CITY OF ALLENTOWN

Denial of a Certificate of Appropriateness – 141 N. 10th Street

**Historical Architectural Review Board
COA Final Review Sheet**

HDC-2023-00060

Detail of porch roof prior to removal.
(Applicant)

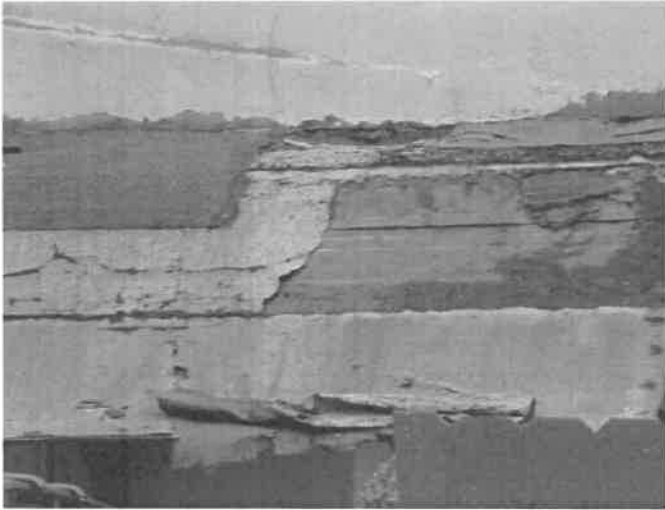
Though located at the rear of the building, the one-story porch was highly visible from the public right-of-way because of its proximity to the Allentown Cemetery, which is located immediately across Hazel Street. The porch also had the distinctive form of the Allentown porch roof, which is the curved projecting roof installed on brackets. The owner contends that the porch roof was in poor condition and beyond repair, and that it had to be removed to comply with insurance requirements.

Staff finds that, because the porch was visible from the public right-of-way and was of the distinctive Allentown porch roof design, the porch should be replicated and reinstalled to match the original. The 1932 Sanborn map shows that the porch had a “composition roof,” and staff suggests that asphalt shingles or a similar material be used, and recommends that the roof be secured on wood brackets to match the original.
